Parts Change Information

Subject: New TR Side Frames for the Print Cylinder **ISSUE NO.: 091**

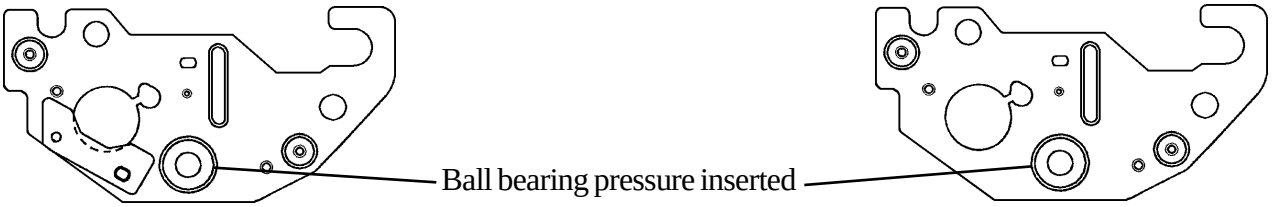
New Squeegee Side Frames have the ball bearings pressure inserted.
The Squeegee (Doctor) Gap should be adjusted to 0.08 ± 0.02mm.
